SANDEL

3308-04 Service Information Letter

Date: 5/25/2000

The following schematic is provided for informational purposes only.

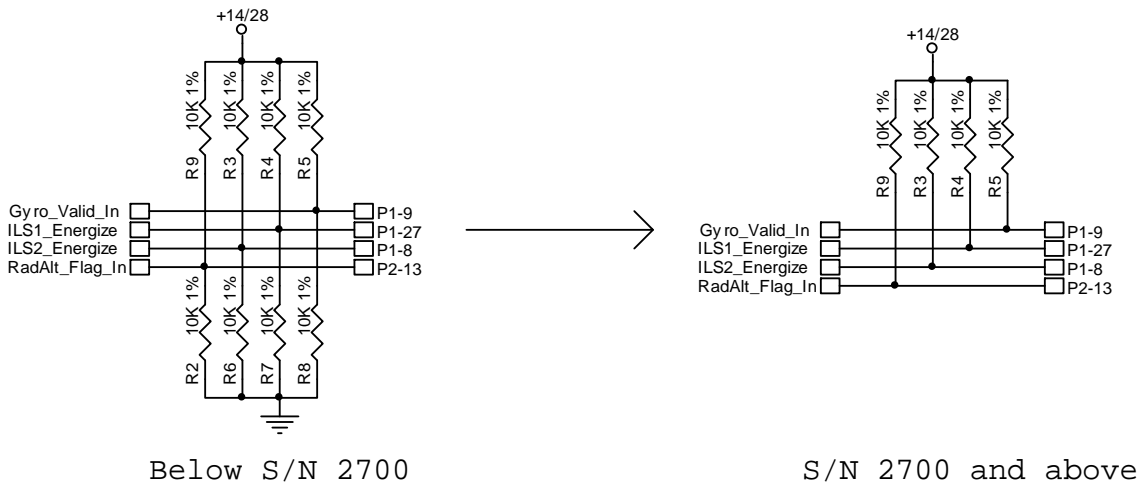
The rear PCBA, containing the connectors for the SN3308, has been revised to eliminate the need for an external pullup resistor on certain inputs in 14v airplane installations, specifically the ILS energize inputs when using Bendix/King VOR/LOC converters. In the original design the input circuit would half pull-up requiring an external pullup resistor for proper operation of the external converter.

<u>Signal Name</u>	<u>Connector-pin number</u>
ILS1_Energize	P1-27
ILS2_Energize	P1-8
Gyro_Valid_In	P1-9
RadAlt_Flag_In	P2-13

This change should not affect the operation of the SN3308 in any existing installations. If an existing external pullup resistor is installed, it may be left in the installation.
